## Addendum No. 2

**Project:** Expand Long-Term Parking & Realign Terminal Exit Road (Ross Drive)  
FWACAA Project No. AF25-01 **CHA Project No.:** 088627.000

**Date:** July 1, 2025

Sheet C6.2.1 – Pavement Marking Details

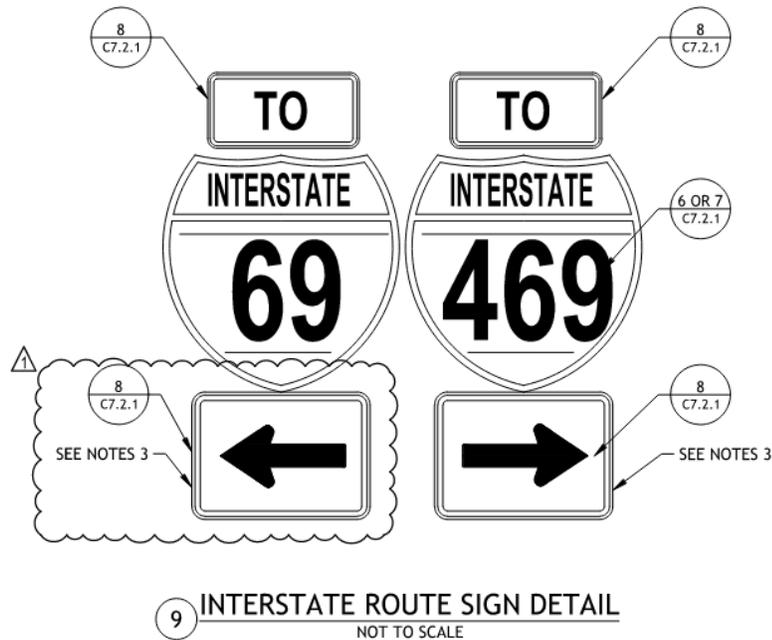
Revision: Pavement Marking Notes 1 and 2 are to be deleted in their entirety and replaced with new Note 1 to read as follows:

**1. ALL PAVEMENT MARKINGS SHALL BE WATERBORNE PAINT FURNISHED AND APPLIED IN ACCORDANCE WITH TECHNICAL PROVISION SECTION 32 12 16. ALL WHITE MARKINGS SHALL INCLUDE REFLECTIVE MEDIA (GLASS BEADS). YELLOW MARKINGS DO NOT REQUIRE REFLECTIVE MEDIA.**

DRAWING NO. U1.2.5

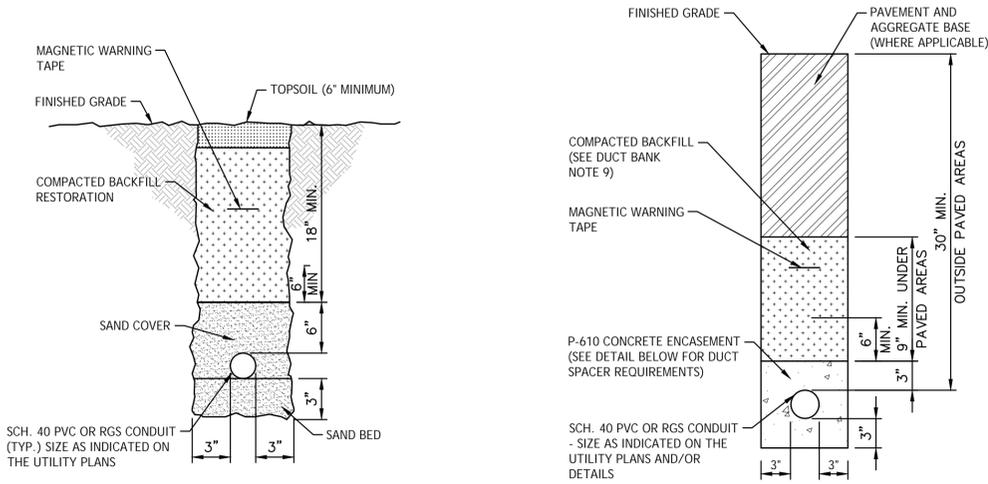
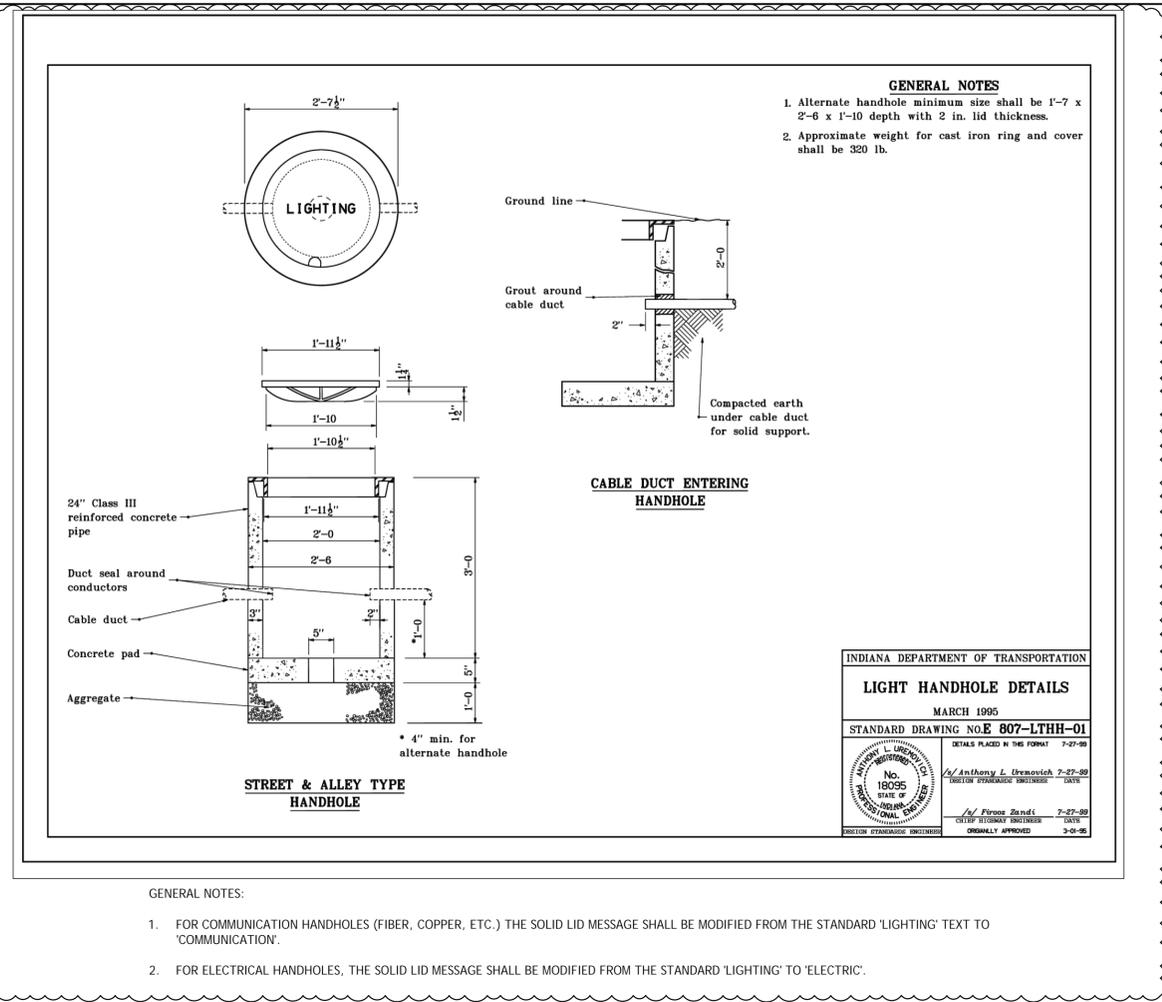
- Electrical & Communication Conduit Schedule updated. All conduits are to be 2" diameter unless noted otherwise.
- Removed Conduit Trench Details 3 and 4 in their entirety.
